**REVIEW OF THE NIOSH SITE PROFILE FOR THE
HOOKER ELECTROCHEMICAL COMPANY**

Battelle-TBD-6001, Appendix AA

**Contract No. 200-2009-28555
SCA-TR-SP2010-0034**

Figure 1. Effect of Resuspension Factors on Dust Concentrations

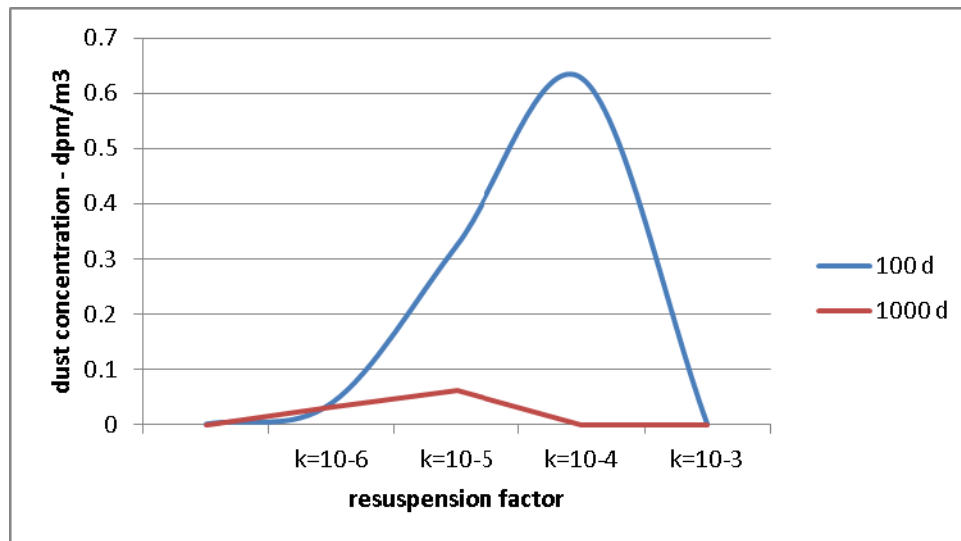
We further note that the method used here of assuming a constant surface concentration during the residual period based on deposition during the final year of the operational period combined with a resuspension factor of $1E-06/m$ is not one of the seven methods proposed in ORAUT-OTIB-0070 (ORAUT 2008). One method proposed in OTIB-0070 is to use the surface concentration at the end of the operation period, a resuspension factor of $1E-06/m$ and an assumed dust concentration decay rate of 1%/day. As pointed out by SC&A in its review of OTIB-0070, a resuspension factor of $1E-06/m$ is equivalent to a decay rate of 0.012%/day based on a room height of 5 m and one air change per hour (SC&A 2008). A decay rate of 1%/day is roughly equivalent to a resuspension factor of $1E-04/m$. If one uses a higher resuspension factor, the initial dust concentration is higher, but the dust concentration falls much more rapidly over time. Figure 1 compares the dust concentration in the air at 100 days and 1,000 days after

cessation of operations for resuspension factors ranging from 1E-06/m to 1E-03/m. It can be seen that after 1,000 days, the dust concentration is greater for a resuspension factor of 1E-05/m than for values above and below.

However, a higher resuspension factor does not necessarily result in a higher integrated inhalation intake. When sufficient time has elapsed, a worker will experience the same integrated intake regardless of the resuspension factor. For the case modeled here, the integrated intake is the same for resuspension factors of 1E-05, 1E-04, and 1E-03/m after 10 years. A considerably longer period is required to reach the same asymptotic value for a resuspension factor of 1E-06/m.

As an alternative, NIOSH could have used an approach where the initial dust concentration was based on surface contamination at the end of operations and an appropriate resuspension factor, and assumed that this decayed exponentially to some value below the detection limit at the end of the residual period.

Finding 9: NIOSH should justify that the approach taken to calculate inhalation exposures during the residual period is bounding, and take into consideration SC&A's review of ORAUT-OTIB-0070.
